SWINDON PARISH COUNCIL

Response To M5 Junction 10 Consultation (Dec 21 – Feb 22)

Figure 2 – shortest alternative route from the M5 to the B4634 via Hayden Road.

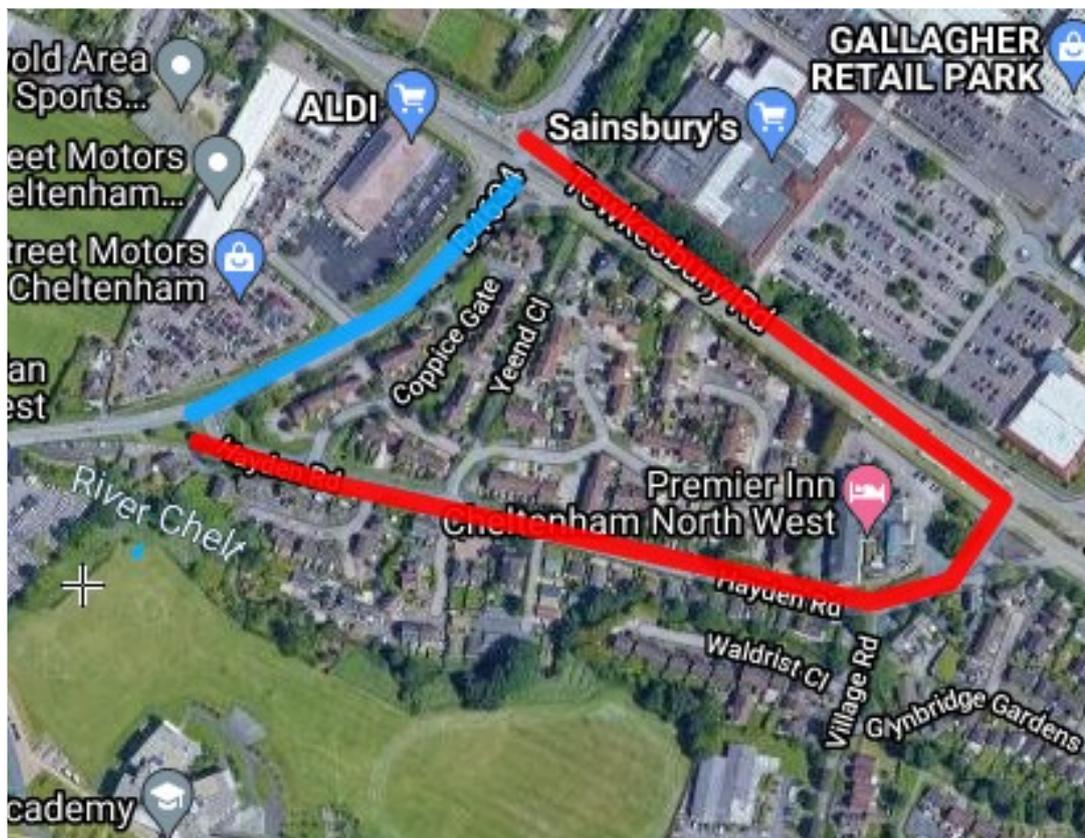
- Via the junction between the A4019 and Hayden Road (see Figure 2, red line). This route would add 0.8km to a typical journey from the M5 to this area. The route includes three minor junctions in addition to the junction with the A4019, a 3-way mini roundabout, a 4-way mini round about, and a T junction as well as disabled parking on the road. The route provides direct access to houses, with some properties being less than 3m from the road curb.
- The next nearest would be via the new link-road which would add on average 3.5km to a journey from the M5 to this area. This involves utilising portions of the B4019 that are bendy and narrow as it climbs over Holmesdale.

Given that (b) represents a significant increase in journey time and length compared to (a), without traffic modelling, it is reasonable to assume that most traffic would use route (a). This would result in:

- A significant increase of traffic using the junction between Hayden Road and the A4019. This would likely result in congestion on the A4019 to the new Gallagher Retail Park junction due to tailbacks, reducing its capacity and increasing journey times, while reducing journey reliability.
- A significant increase of traffic using Hayden Road. The 3-way mini roundabout, with the junction between Hayden Road and Village Road is of particular concern, noting that during peak times these experiences congestions.
- Reduction in accessibility for pedestrians crossing the road, noting that the link with Village Road is a major pedestrian route as it links the Gallagher Retail Park with Springbank. Additional Hayden Road is a popular pedestrian route for accessing central Cheltenham from NW Cheltenham (either via Tewksbury Road or parallel to the Chelt, via Princess Elizabeth Way).

As such, access onto the B4364 from the east bound A4019 must be maintained and an alternative junction design must be proposed. There is significant land immediately to the

Figure 4 - Priority access requirements for non-vehicular traffic (proposed in red, suggested connection in green).

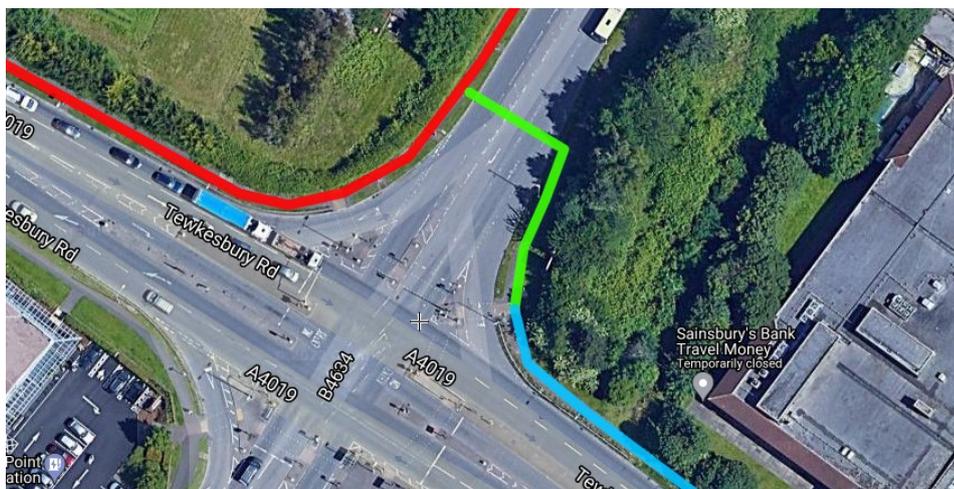
The active travel corridor currently terminates into the junction at the North end of Gallagher retail park. To link up with existing (blue) and planned cycleways (red) it needs to continue down Tewkesbury Road to link up with the junction with Manor Road / Hayden Road (green) ().
